UNIFIED SCHOOL DISTRICT NO. 338
USD 338 VALLEY FALLS FITNESS AND CLASSROOM ADDITION
CONSTRUCTION BID DOCUMENTS
ADDENDUM NUMBER FOUR (ADD-04)
ISSUED: JANUARY 02, 2009

TO DOCUMENTS TITLED: Unified School District No. 338
USD 338 Valley Falls Fitness and Classroom Addition
Construction Documents

DATED: November 13, 2008

REF: ADDENDUM NO. 4 PROJECT NO: 2008-001 DATE: 01-02-09 CAD DWG FILE: A101.DWG		DRAWING TITLE FLOOR PLAN KEYED NOTES
		PROJECT USD 338 VALLEY FALLS FITNESS AND CLASSROOM ADDITION
		M.C Lieb Designs, LLC 14 West 3rd Street Suite 150 Kansas City, Missouri 64105
		DRAWING A101-R4

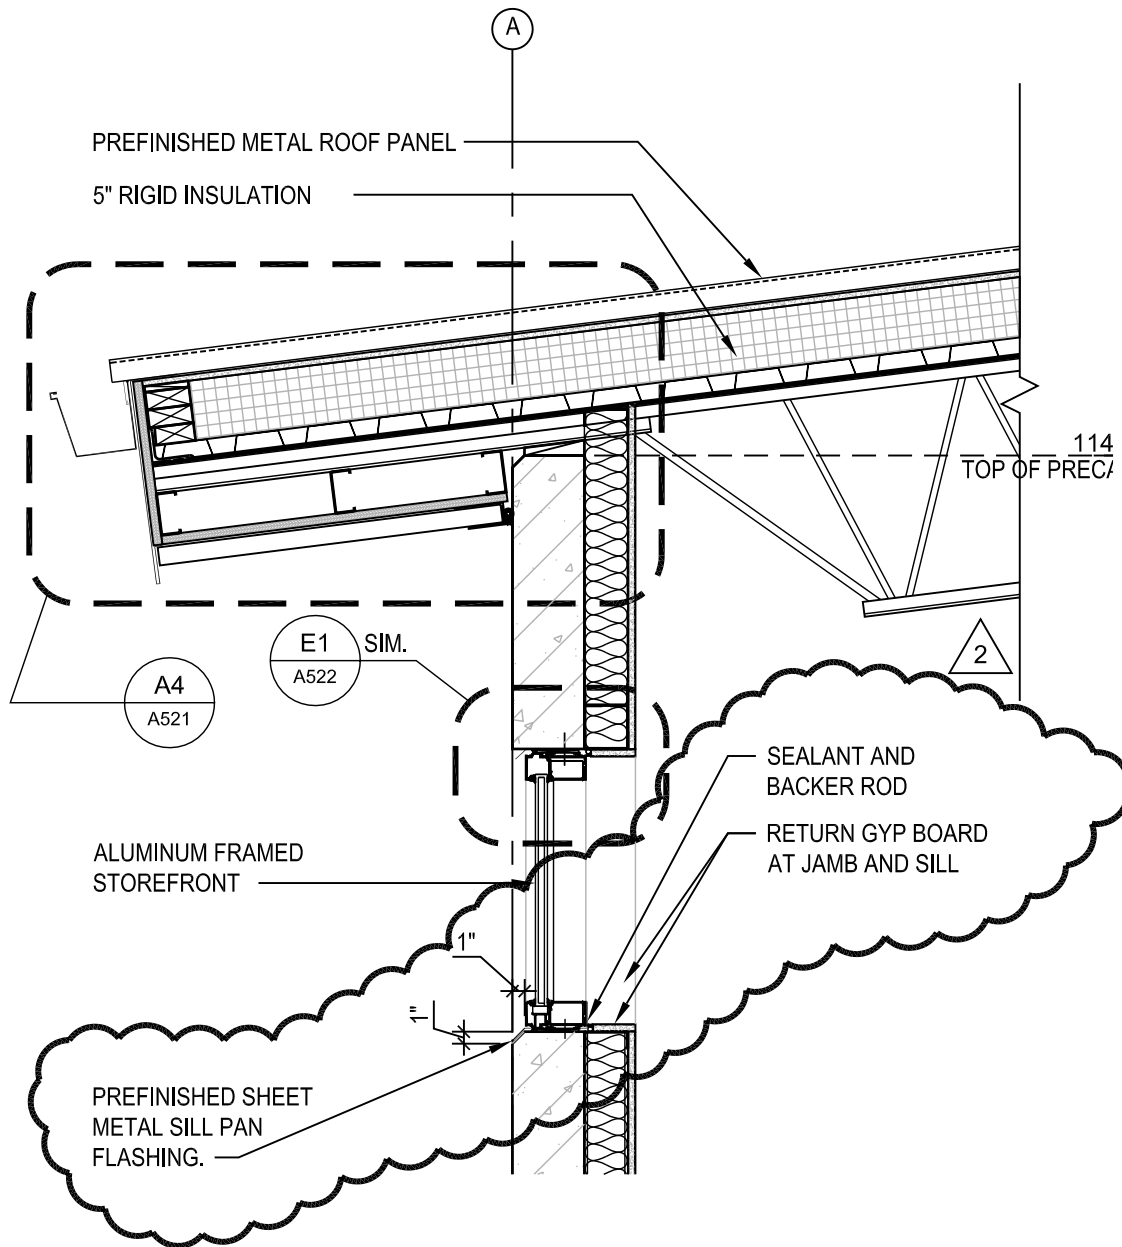
1. Sheet A101
 - a. Revise drawing as indicated on attached supplemental drawings A101-R3 and A101-R4 dated 01-02-09.
2. Sheet A321
 - a. Revise drawing as indicated on attached supplemental drawing A321-R2 dated 01-02-09.
3. Sheet A522
 - a. Revise drawing as indicated on attached supplemental drawing A522-R2 dated 01-02-09.
4. Sheet M201
M201 ROOFTOP AIR HANDLING UNIT SCHEDULE
RTU-02 MCA=209, MOCP=250
5. Sheet E401
PANEL MDP, CHANGE CIRCUIT BREAKER FEEDING RTU-02 TO 250AMPS
6. Sheet E201
